Application of Future Capital Investment for a Major Modification to zoning conditions pursuant to CZ-20-1243972 to reduce the number of single-family detached lots from 19 to 6 lots in the RSM (Small Lot Residential Mix) zoning district, at 1347 Bermuda Road.

PETITION NO: D8-2022-2260 CZ-22-1246090

Case No.: CZ-22-1246090 **Agenda #:** D8

Request: A major modification to zoning conditions pursuant to CZ-20-1243972 to reduce the number of single-family detached lots from 19 to 6 lots.

SITE PLAN

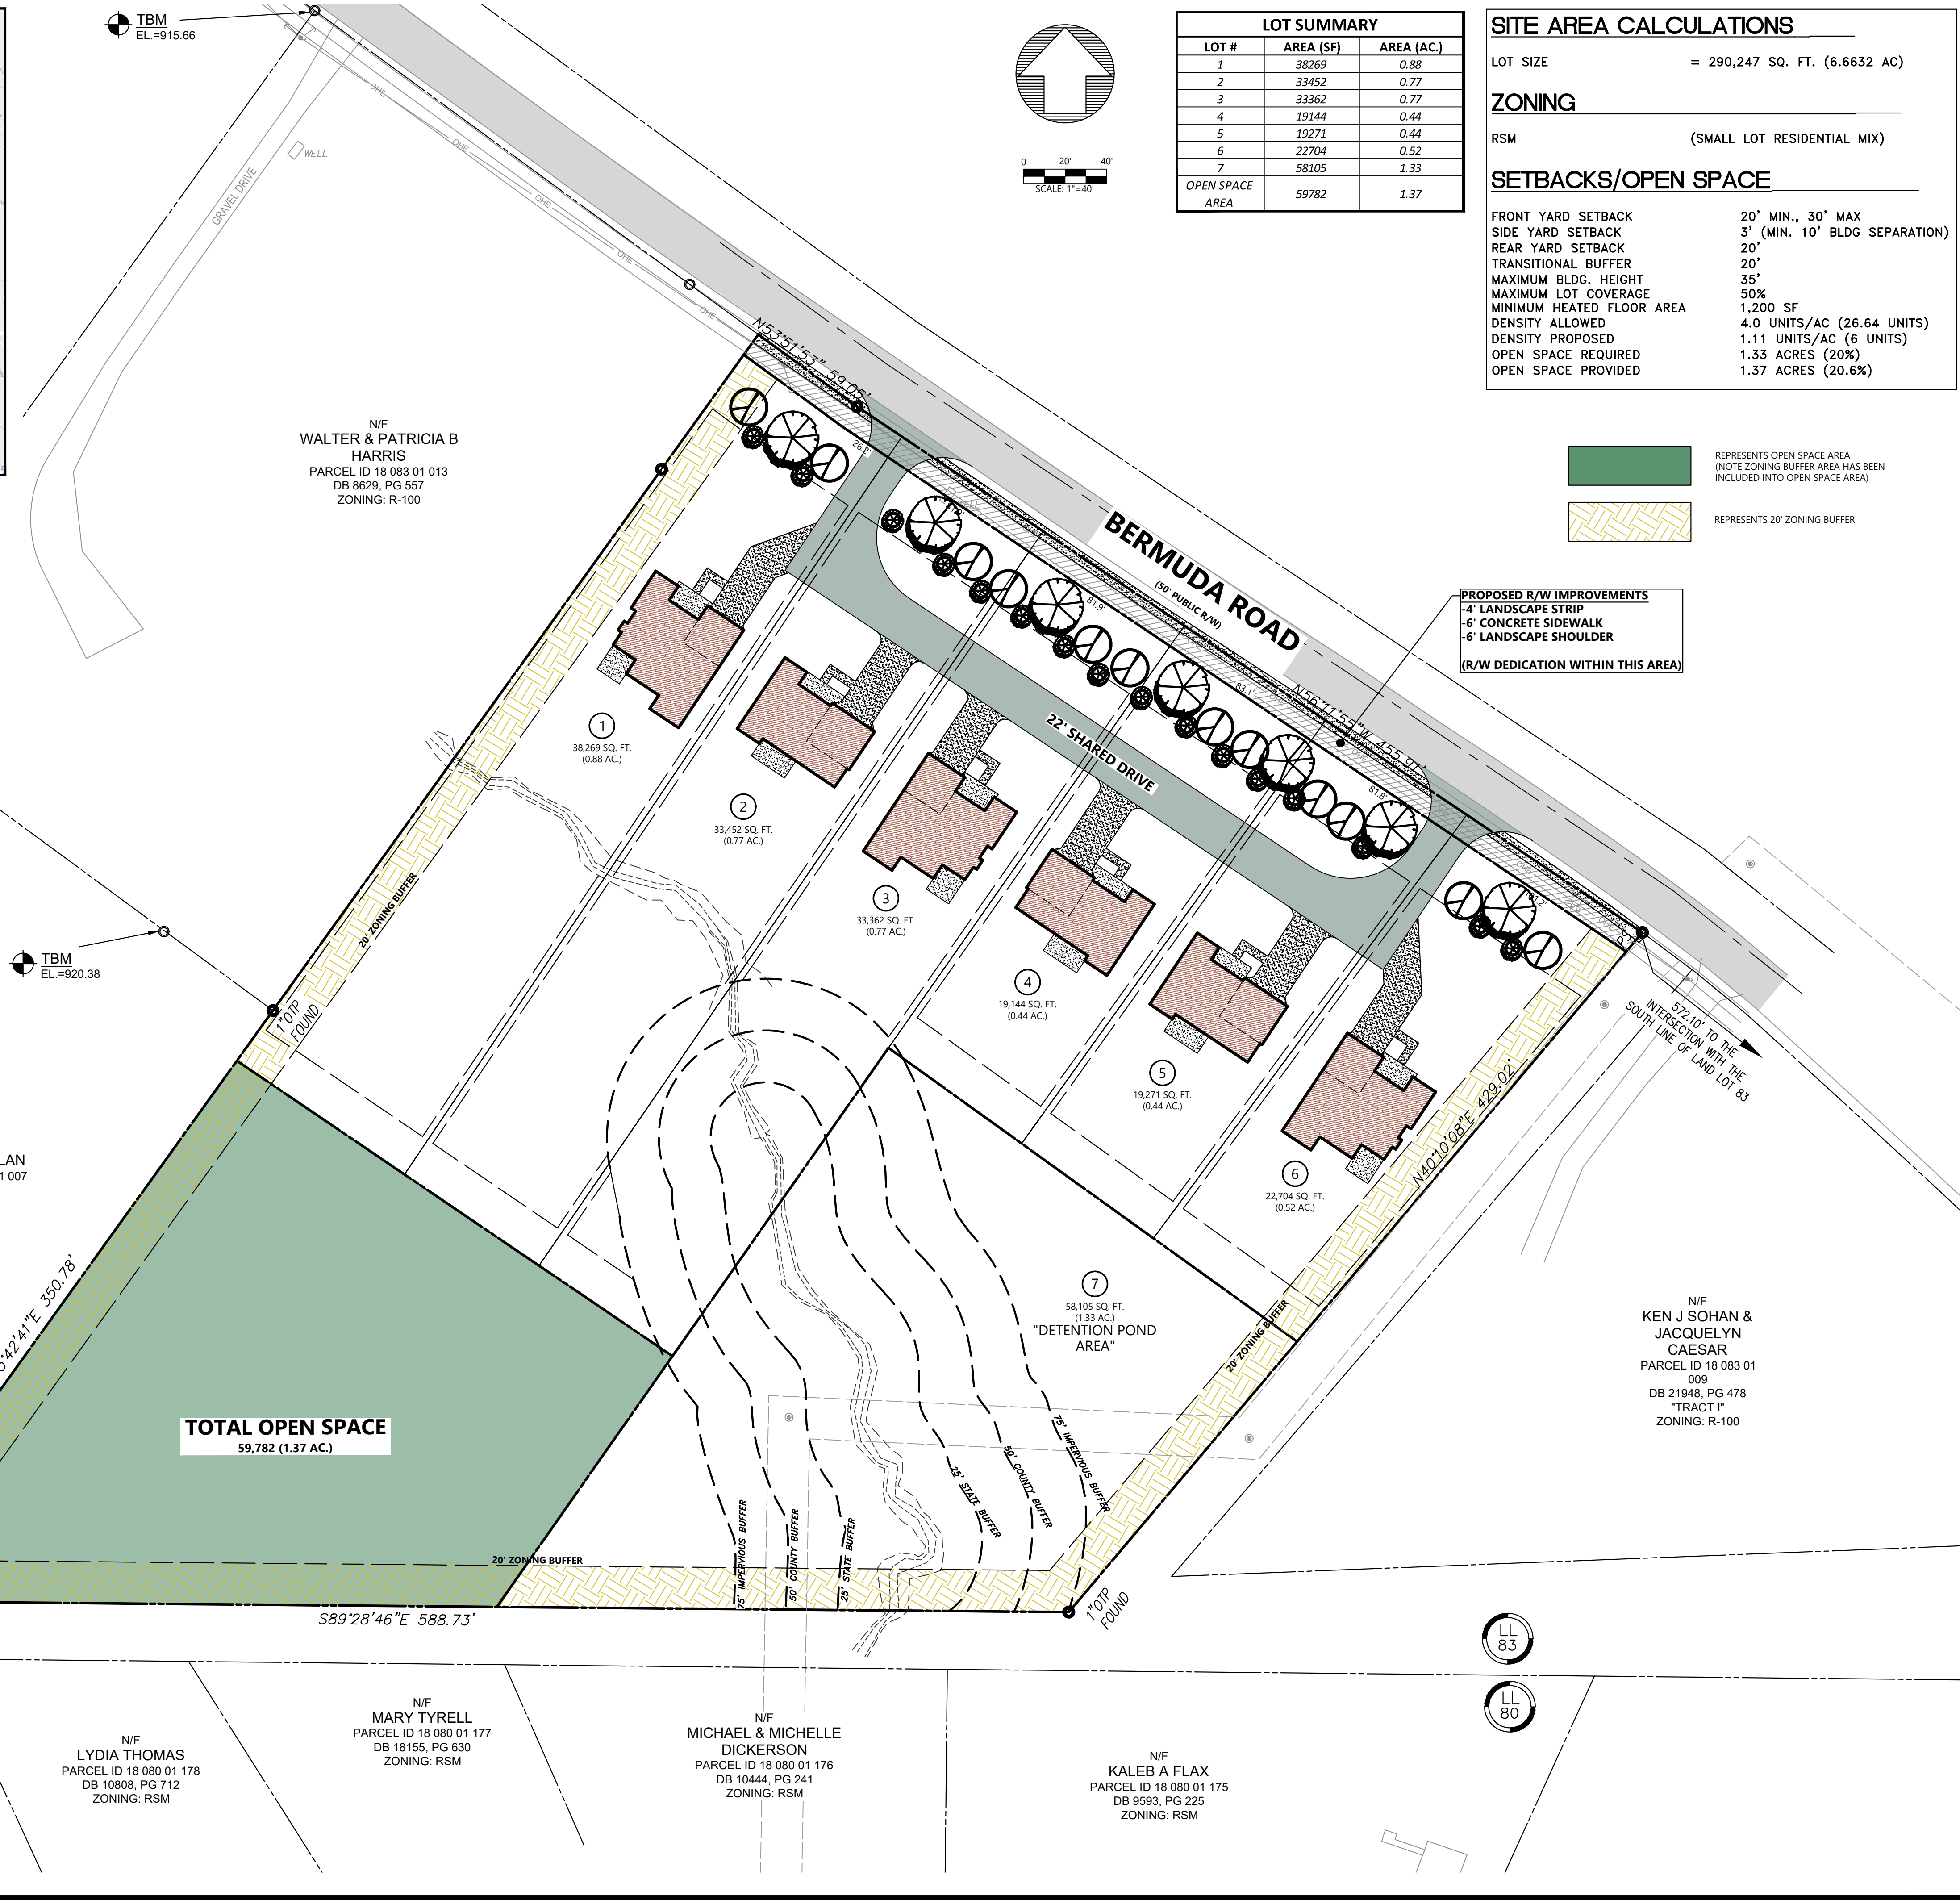
Conceptual plan doesn't indicate the location of the stormwater management facility. Location of stormwater management shall be shown or compliance with the County stormwater management regulations shall be explained.

Additional consideration must be given to the 10% downstream analysis. Runoff Reduction Volume shall be provided unless technical justification is provided regarding the unfeasibility. Strongly recommend investigating the site and identify location where RRv can be provided and re-design/revise the layout to comply with the RRv requirement.

- N10. 1347 Bermuda Road.** By Code- shared driveways can only be for 2 lots. A variance will be necessary to have 6 lots on a shared driveway. Suggestion: widen to 24 feet and make it a private road. Bermuda Road is classified as a collector road. requires a right of way dedication of 35 from centerline OR such that all public infrastructure is within right of way, whichever greater. Requires a 5 foot landscape strip with a 10 foot mulituse path. No poles may remain within the limits of the path. Requires pedestrian scale streetlights. Watch minimum separation of drives/roads in section 14-200(6) based on the speed limit of the road.

Possible Variances: Proposed shared drive will be reviewed to verify compliance with Transportation Department and Zoning Ordinance requirements. From a conceptual standpoint Planning Department would prefer the access drive to provide access to the rear of the proposed lots. Show compliance with RSM requirements including but not limited to minimum lot area and lot width, required parking, parking lot landscaping, minimum open space, maximum building height, transitional buffers, streetscape improvements (sidewalks/street trees/street lighting), building materials, outdoor lighting, etc. The applicant is encouraged to discuss possible transportation improvements that may be required (if the rezoning is approved by the Board of Commissioners) with the county Transportation Department. The applicant is encouraged to contact Land Development Division of Public Works regarding required storm water management, floodplain, and stream
